FIELD CHANGE ORDER

NO. 18-019

MANUFACTURING EFFECTUATION LAM116/37140 and upwards.	EQUIPMENT AFFECTED RC 3500 RC 35-103/104/LAM 116 Low-speed Asynchronous Multiplexer
NOTE

SCOPE Change of timing components in monostable circuits on PCBA pos. 5. With the tolerances in the timing components and in the IC (74123), the "LOAD DATA" and "LOAD CONTROL" pulse can override (IN TIME) the "CLEAR DATA OUT" pulse.
--

NO.	18-019
PAGE	3 OF 4

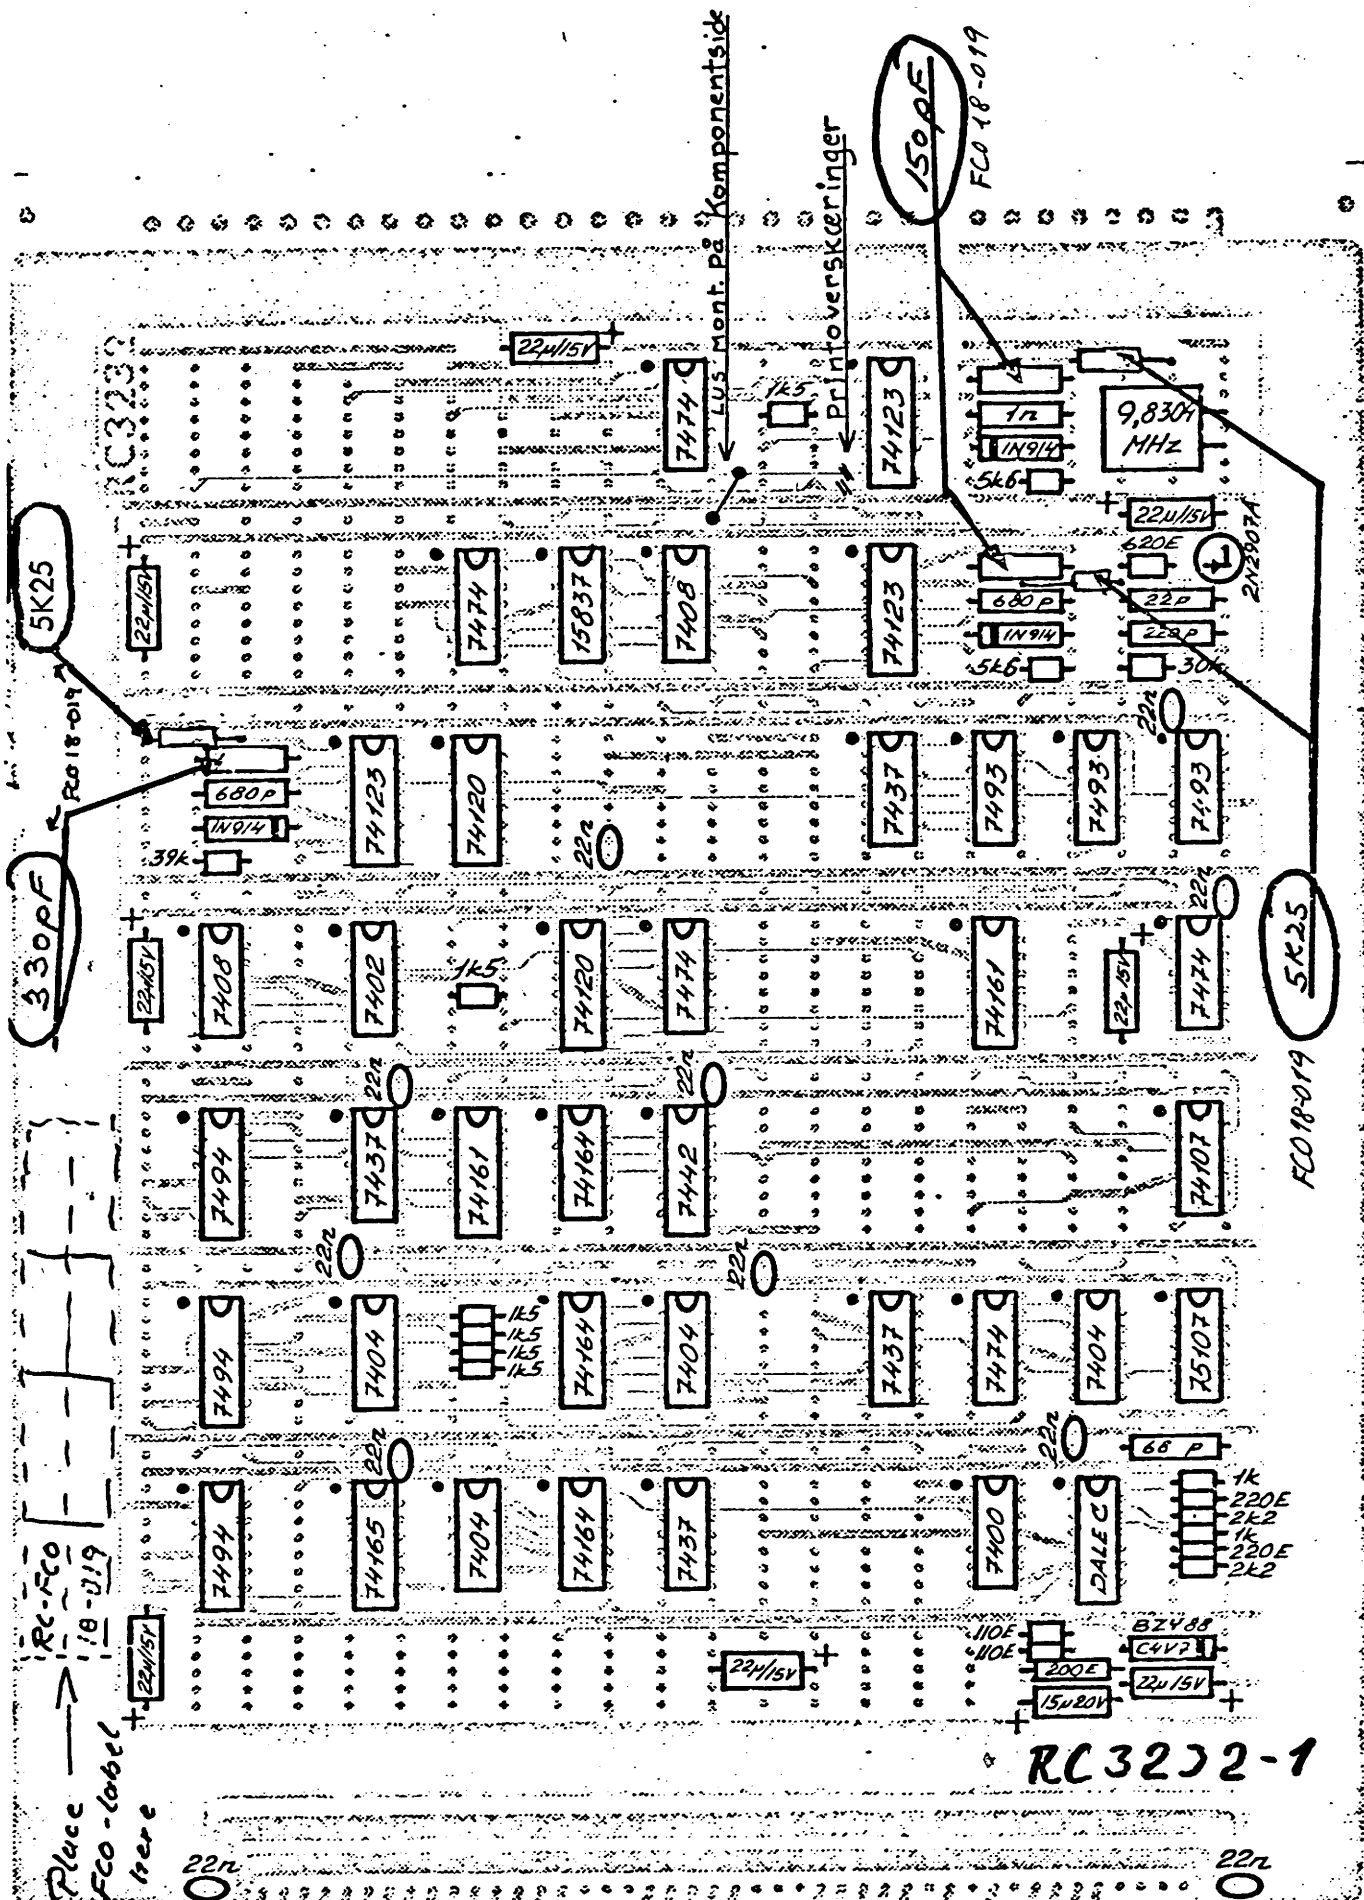
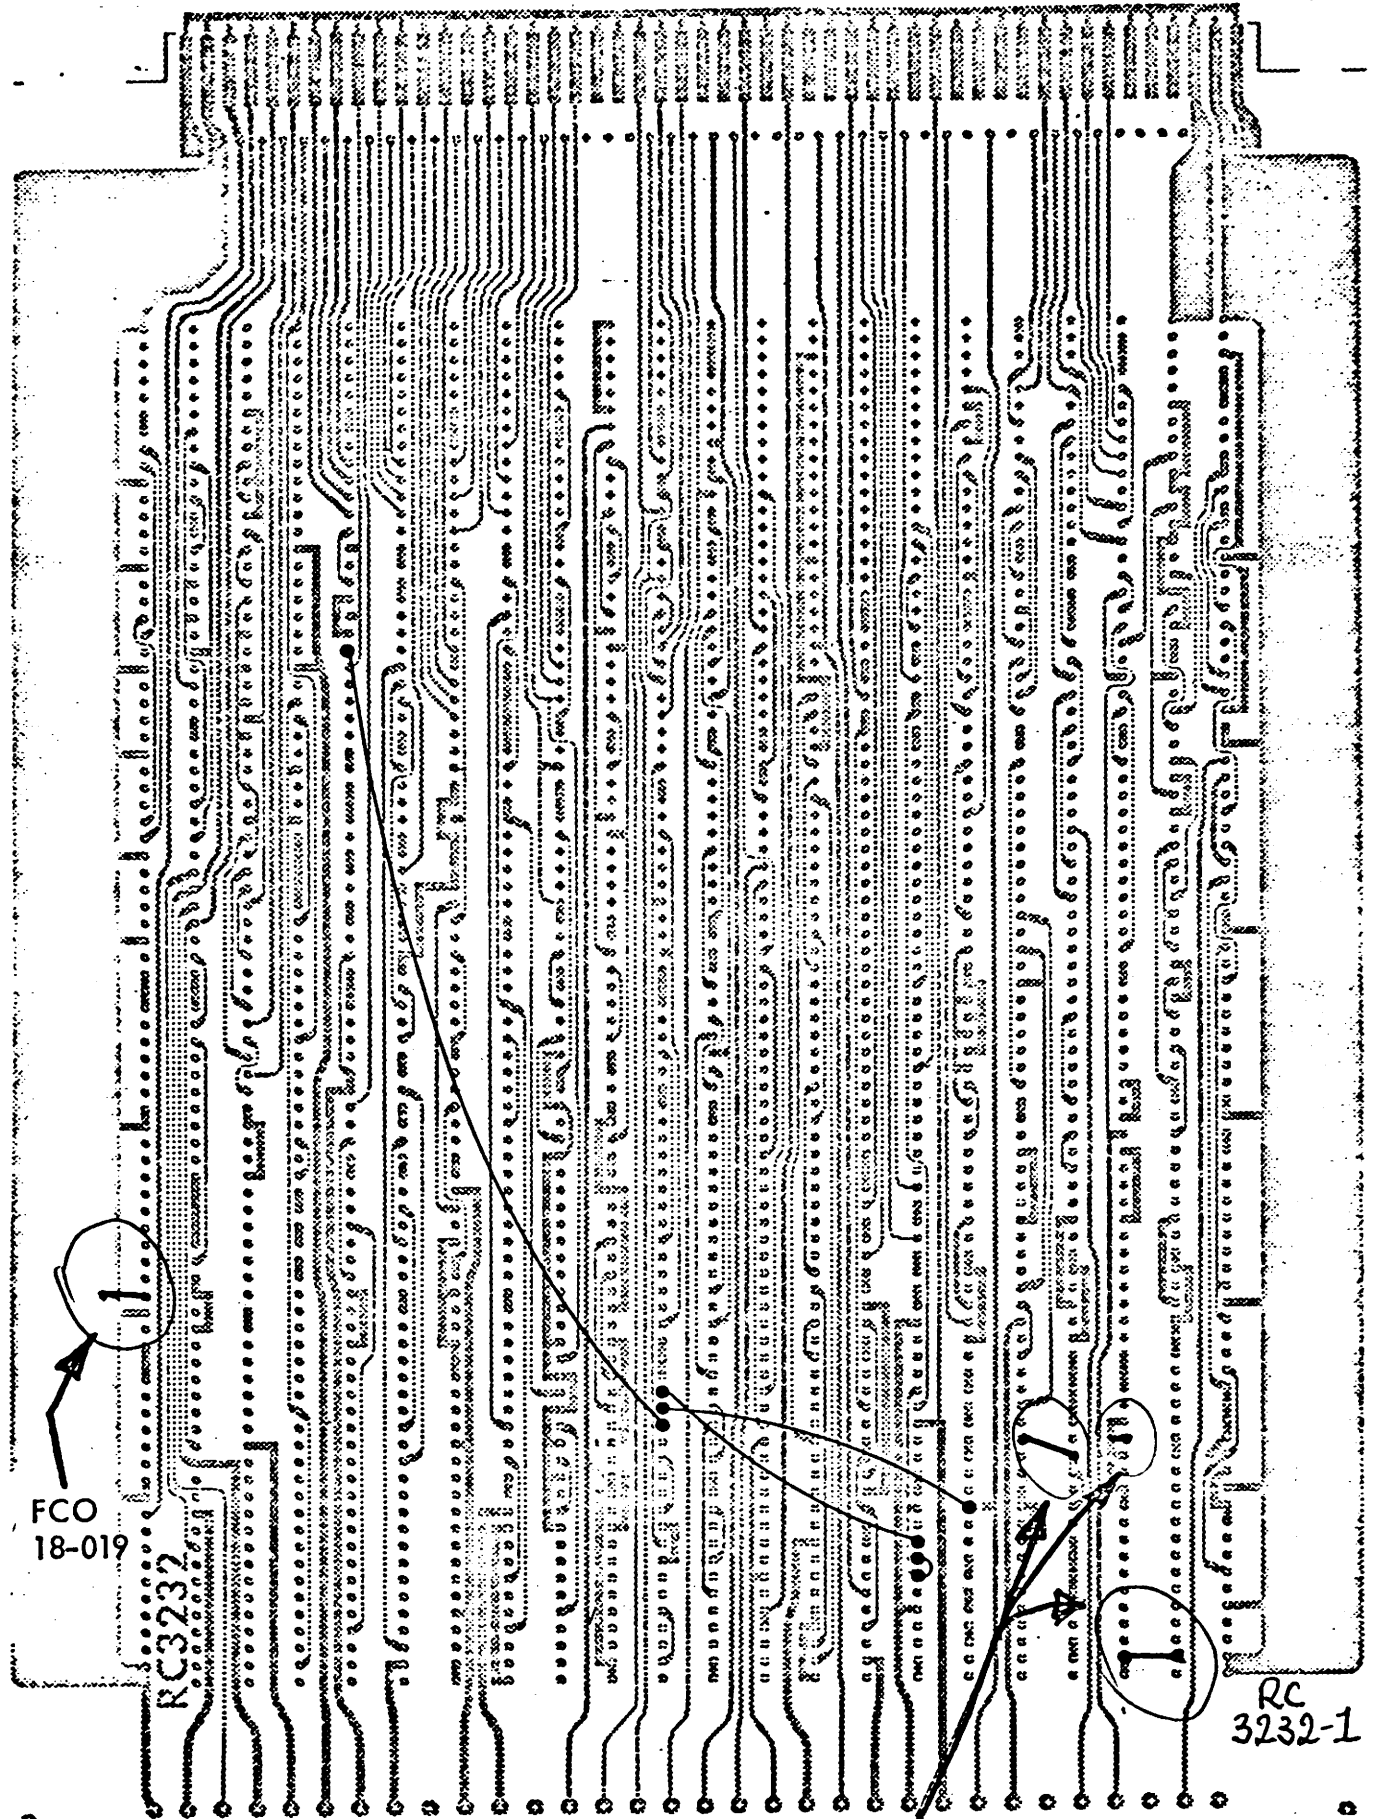
FIELD INSTRUCTION 1. Remove 3 resistors 5K6 1/20W in pos. H18, JJ11 and LL6. Remove 3 capacitors in pos. H18 (470pF), HH12 (220pF) and HH7 (220pF). see page 2. 2. Insert 330pF ± 5 o/o in pos. H18, 220pF ± 5 o/o in pos. H12 and HH7. It is necessary to relocate the 3 resistors (see pages 3 and 4). 3. Place a FCO-Label on the PCBA according to page 3, and code it 18-019.
--

Unit
LAM 108/116
Dwg. No.
A13057

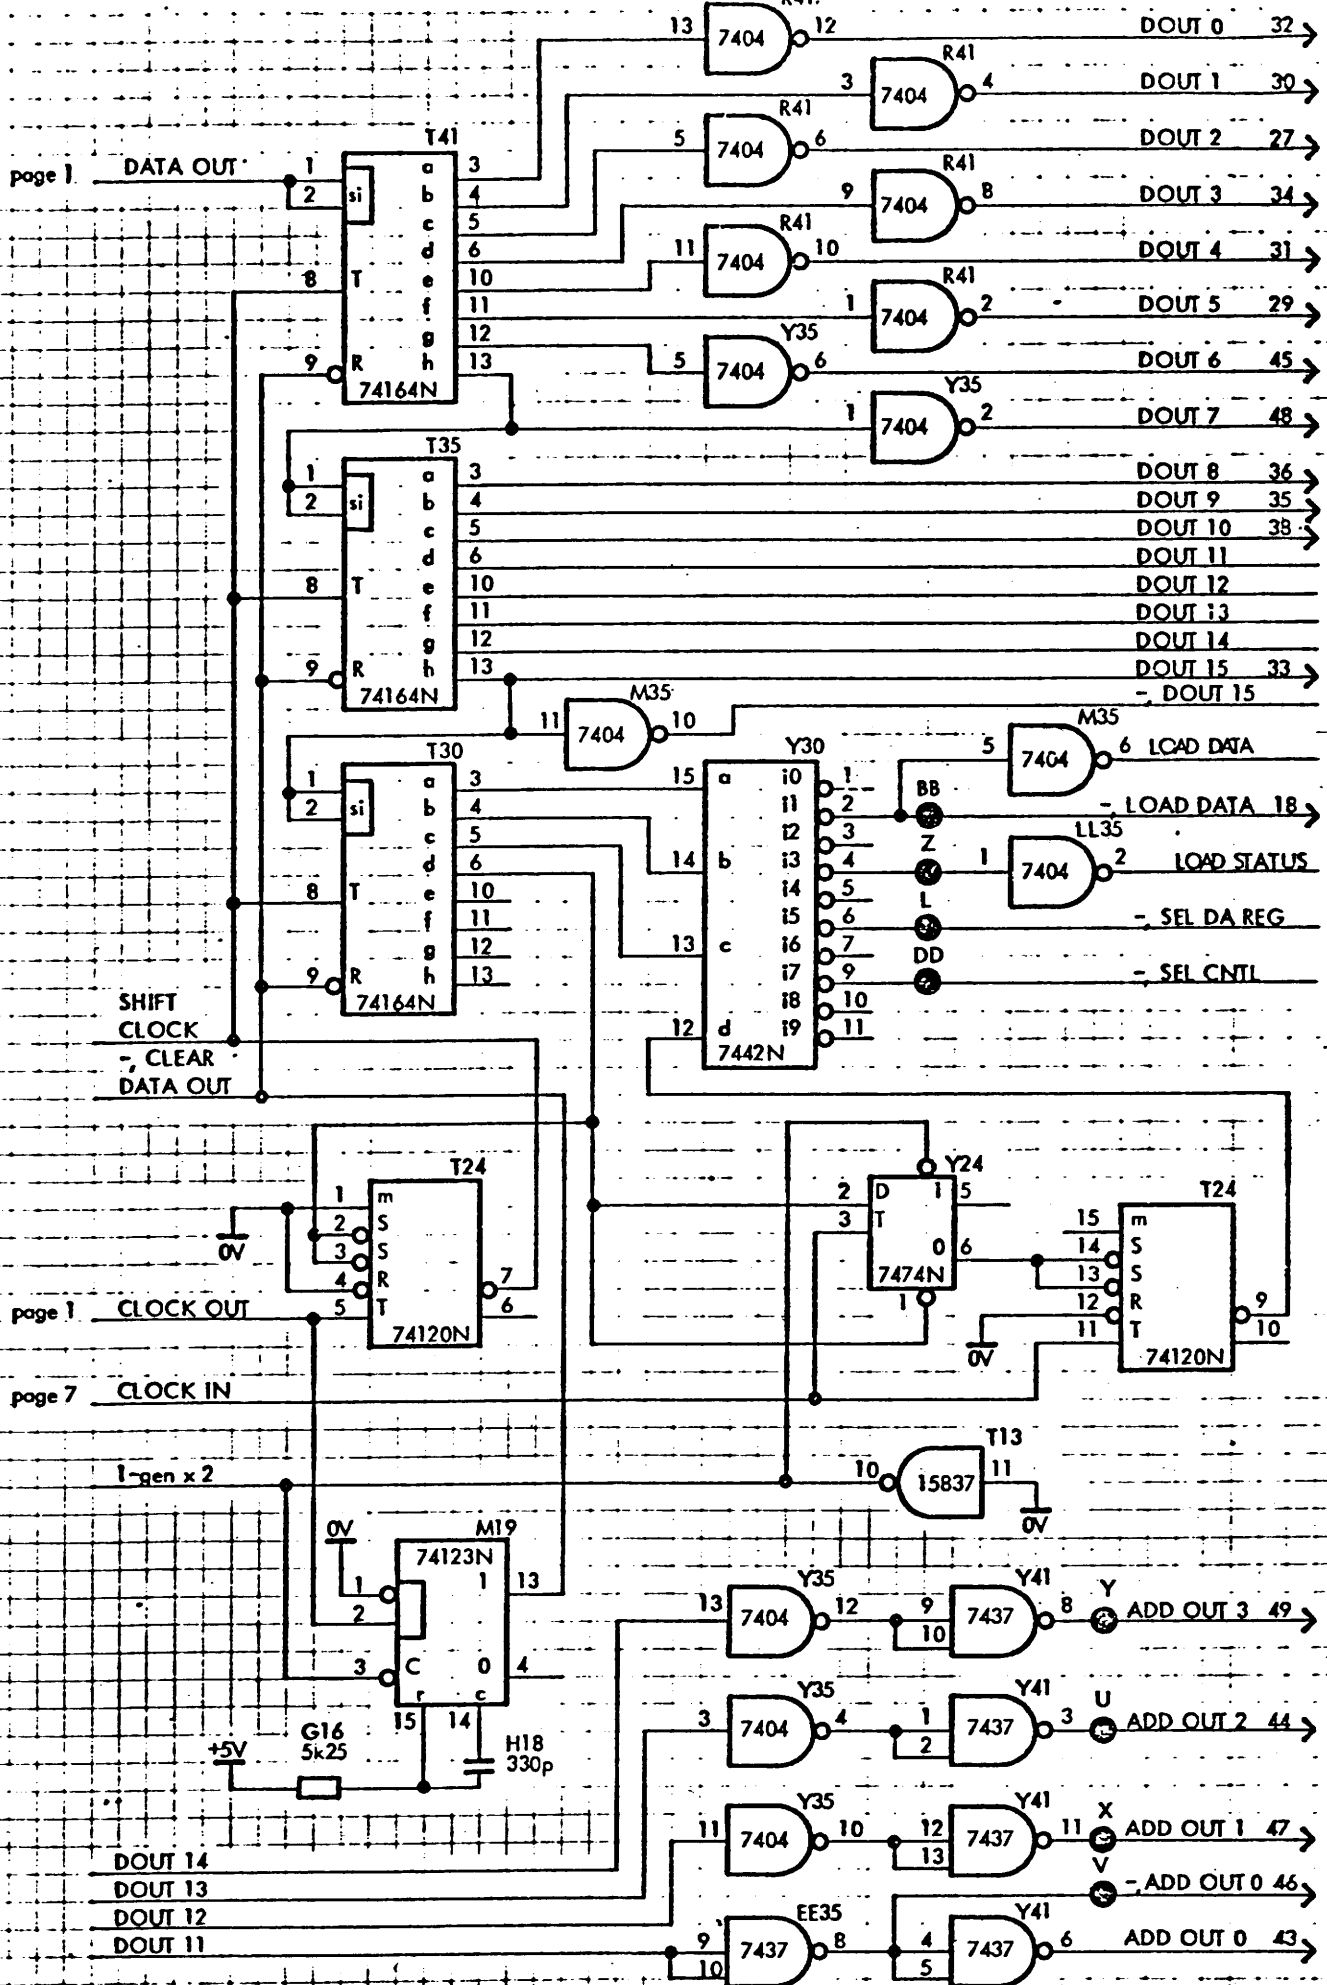
QTY	PARTS REQUIRED	RC - P.N	DOCUMENTATION ENCLOSED
3	5K25 1 o/o 1/8W	0115-19-137	Circuit Diagram A11553 is replaced by A13057.
2	150pF ± 5 o/o	1-1003	Circuit Diagram A11556 is replaced by A13058
1	330pF ± 5 o/o	1-5217

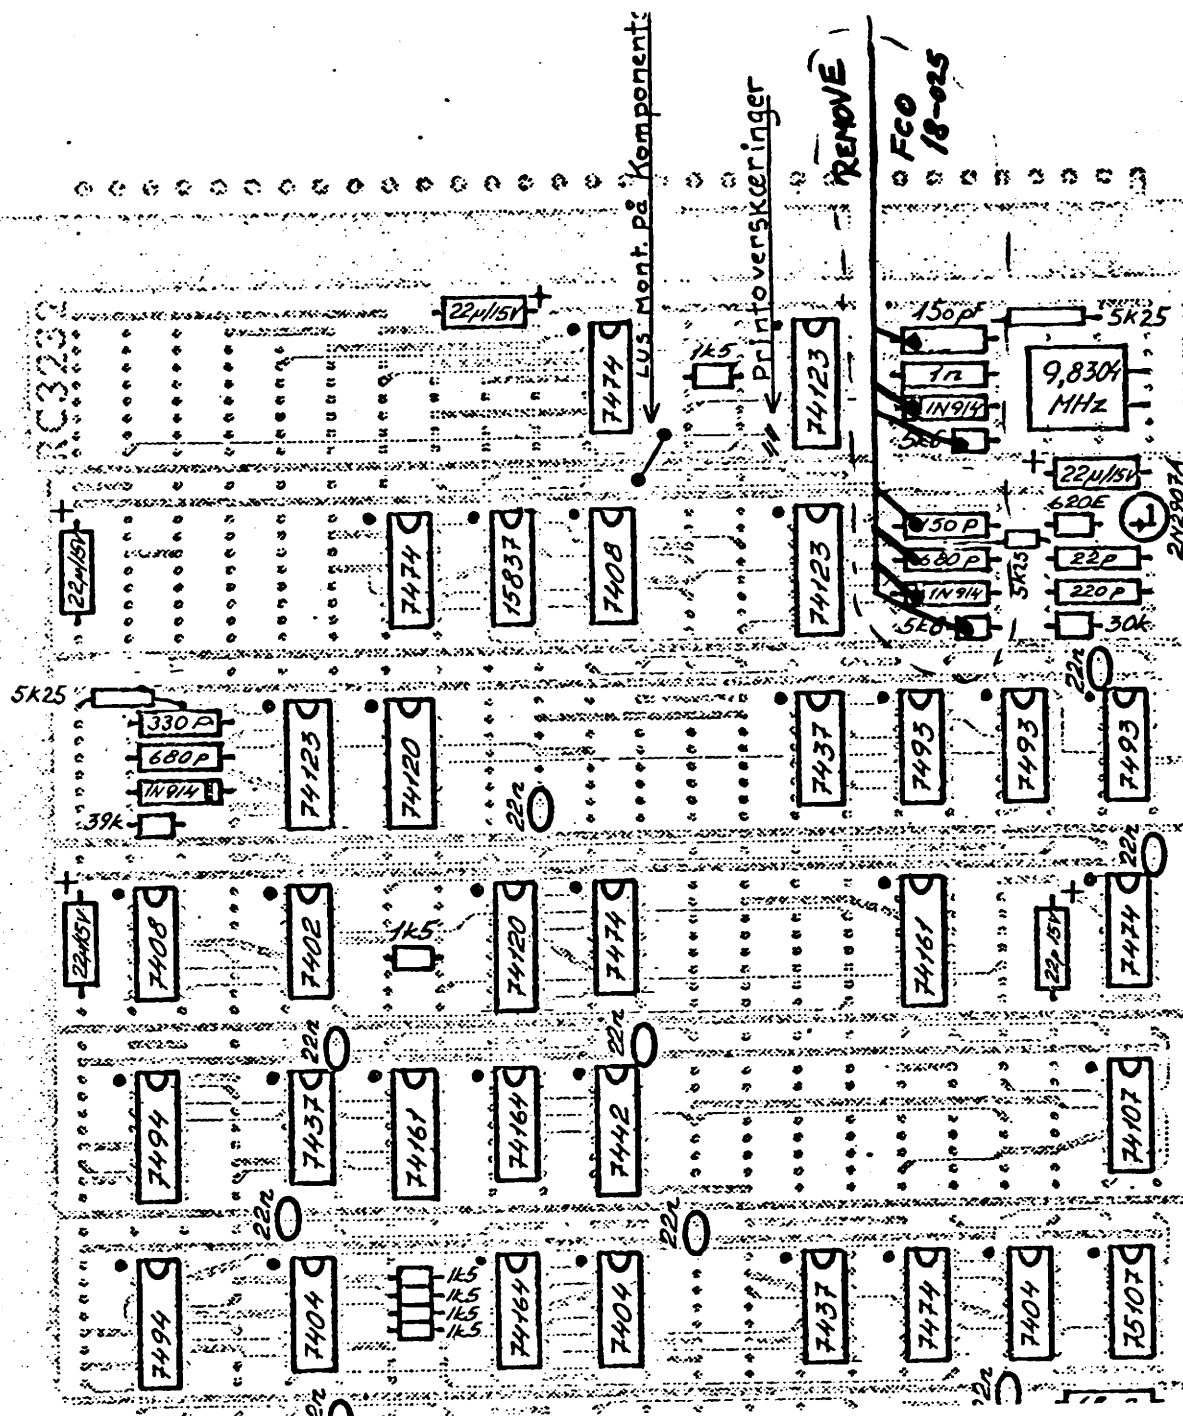
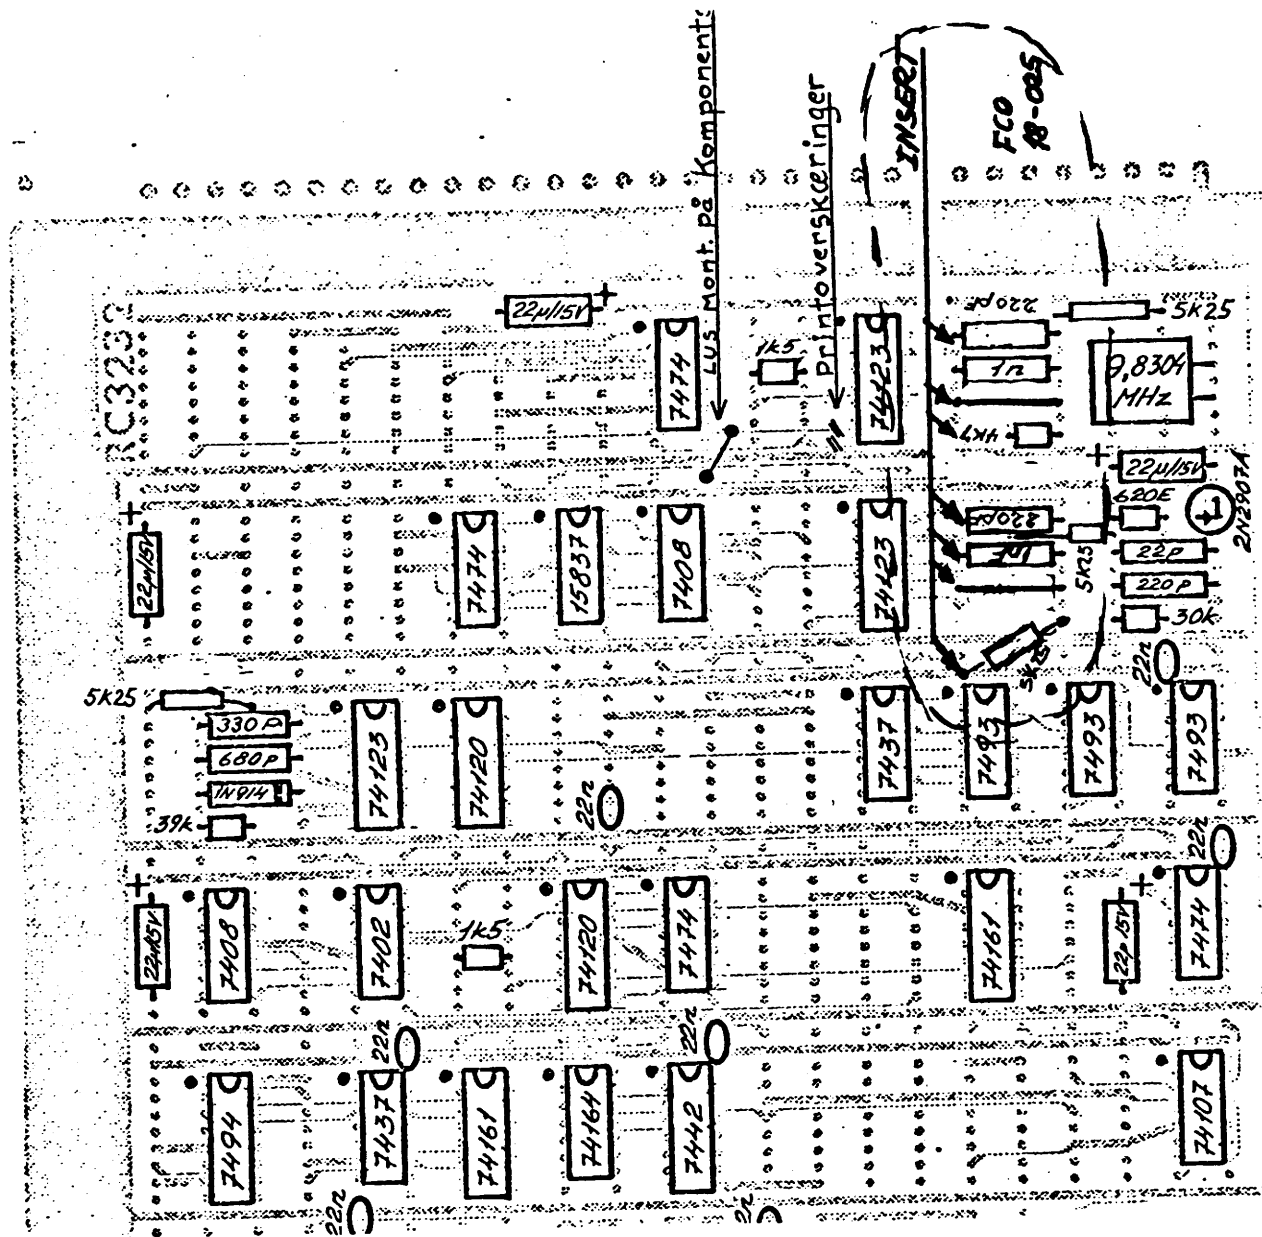
DESCRIPTION OF CHANGE 1. Remove : 2 resistor 5K6 1/20W in pos. JJ10 and JJ15. (see page 2) 2 diodes 1N914 in pos. HH9 and HH14. 2 capacitors 150pF in pos. HH7 and HH12. 1 capacitor 680pF in pos. HH13. 2. Insert : 1 resistor 4K7 1/20W in JJ10. (see page 3) 2 capacitors 220pF in pos. HH7 and HH12. 1 capacitor 1nF in pos. HH13. 2 jumper in pos. HH9 and HH14 (instead of the removed 1N914). 1 resistor 5K25 in JJ15 (see page 3). 3. Code the FCO-Label 18-025.
--
